CPC2017-289
Attachment 3
Letter 1

Re: Council Public Hearing September 11, Truman's Memorial Drive NW, LOC Application (LOC2016-0346), 922, 926, and 928 Memorial Drive NW

MEMORIAL DRIVE

APPLICATION SUMMARY & WHAT WE HEARD REPORT

BUILDING HEIGHT DIAGRAM

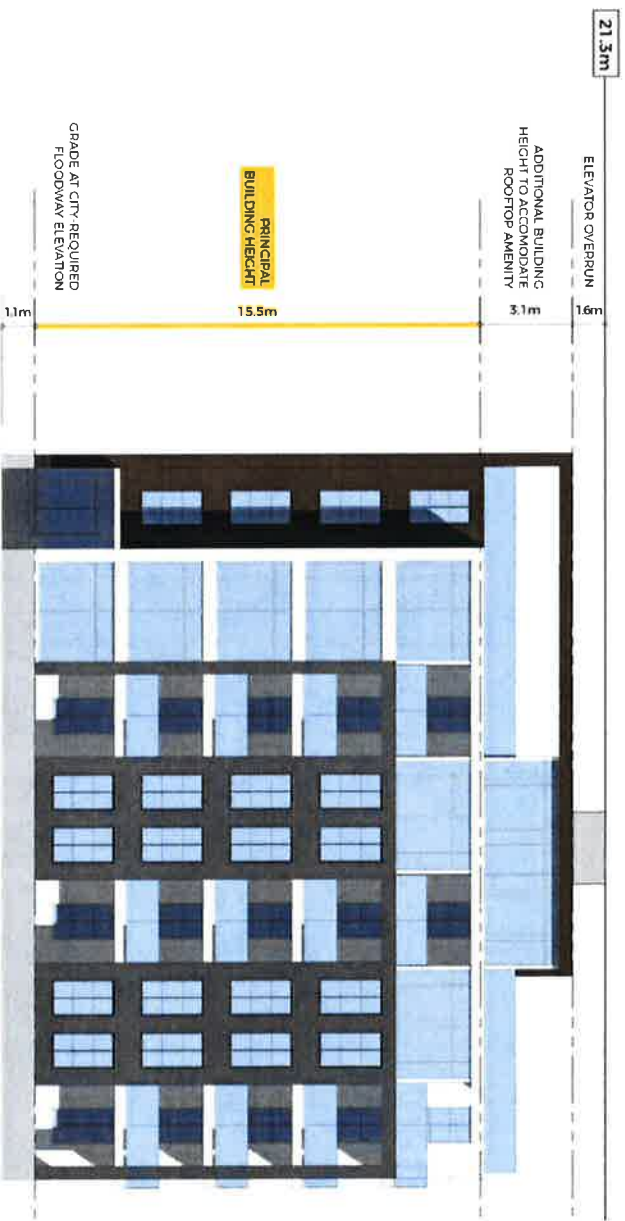
Proposed building too high by one story.

The building plan is 1 story too tall and the building is too wide for the site.

building design and materials are nice, should only be 4 stories to match other height (16m-ish)

4 VS 5 STOREYS - COMPARATIVE SUN SHADOW STUDY: Summer (June 21st)

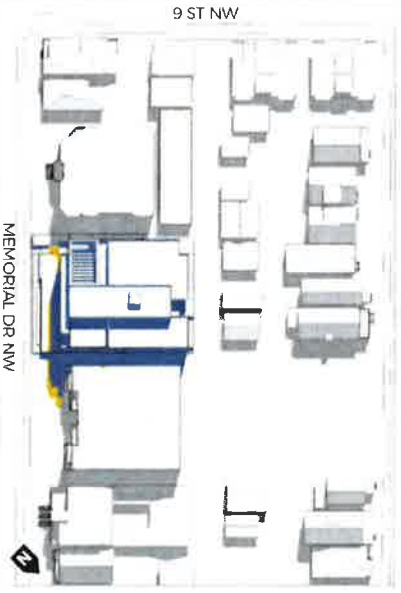
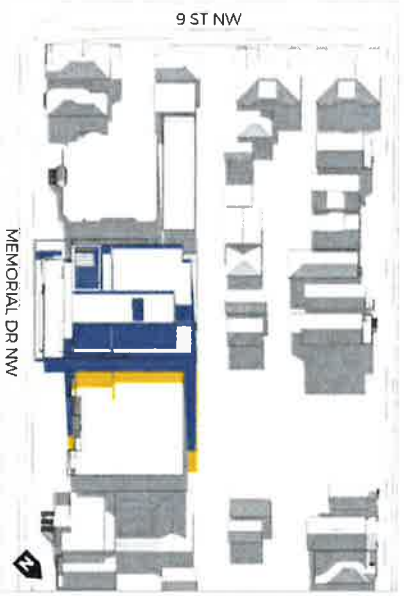
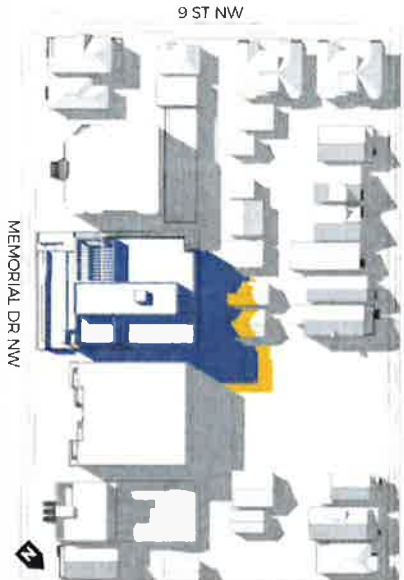
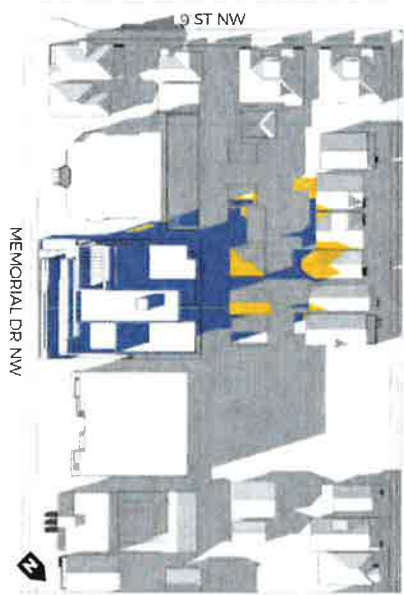
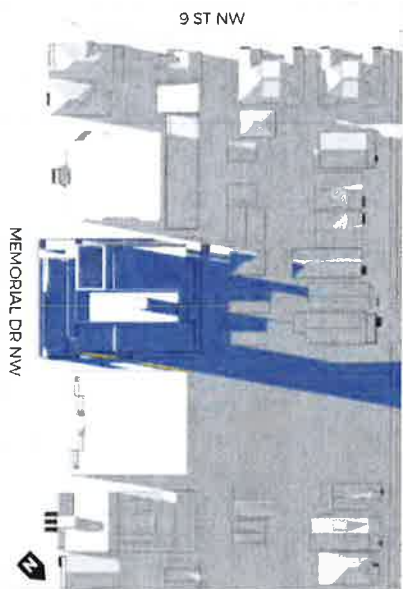
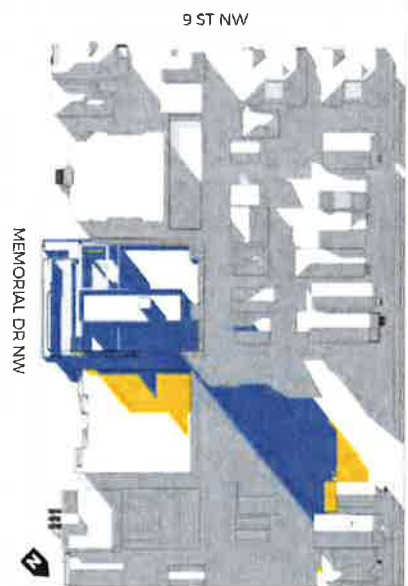
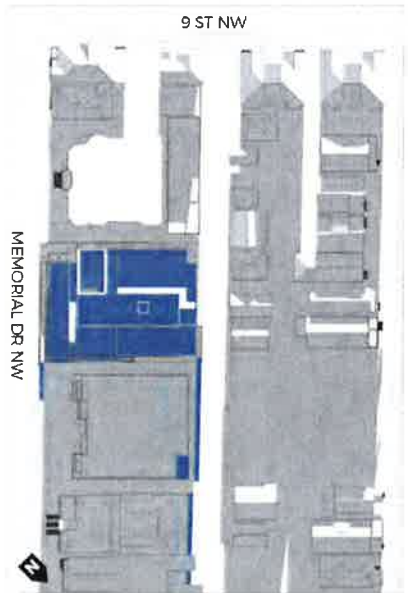
"This proposed development is above what we understood was the maximum height in this neighbourhood and will cause shadowing over the entire east side of our building."

"If the overall planned height of the property was decreased to similar heights already on the block, this would allow for less of a shadow onto properties that have been in Sunnyside for years."

During the engagement process, there were several clarifying questions from participants surrounding the shadow impact related to the mid-rise building. In order to respond to these questions, the project team created additional sun-shadow diagrams to illustrate building impact.

The following Comparative Sun-Shadow Studies illustrate the shadow impact of the proposed five storey building (shown in yellow), as compared to the shadow impact of the building if it were one storey lower (shown in blue), as suggested by some community members.
